19VARIANCE1004 Bishop Street Variance

Louisville Metro Board of Zoning Adjustment Public Hearing

Zach Schwager, Planner I March 18, 2019

Site Plan

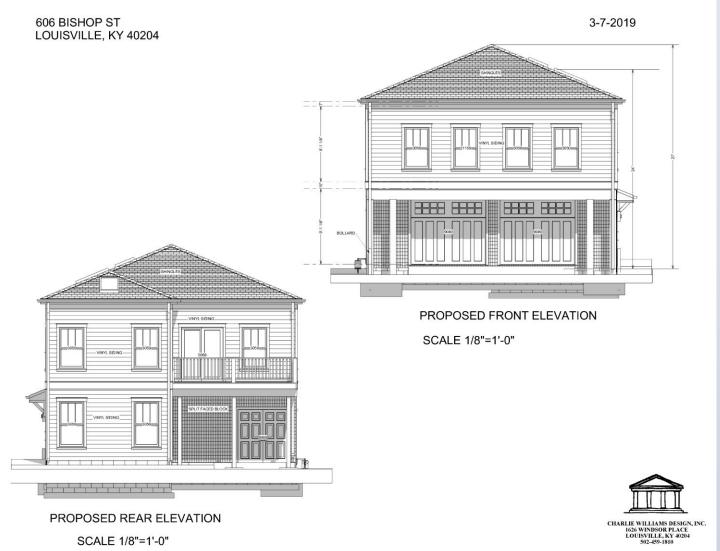
Location	Requirement	Request	Variance
Front yard	15 ft.	5 ft.	10 ft.

- The subject property is located in the Irish Hill neighborhood.
- The applicant requests a variance for a proposed single-family residence to encroach into the front yard setback.
- The applicant requests a waiver to allow an attached front loaded garage to exceed 50% of the front façade

The variance request appears to be adequately justified and meets the standard of review.

The waiver request appears to be adequately justified and meets the standard of review.

Elevations

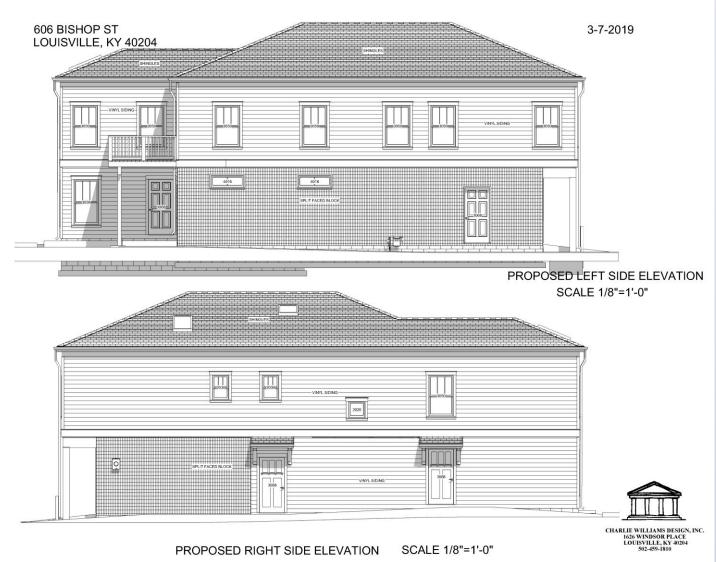
- Variance: from Land Development Code table
 5.2.2 to allow a principal structure to encroach into the required front yard setback.
- Waiver: from Land Development Code section
 5.4.1.C.3 to allow an attached front loaded garage to exceed 50% of the front façade.
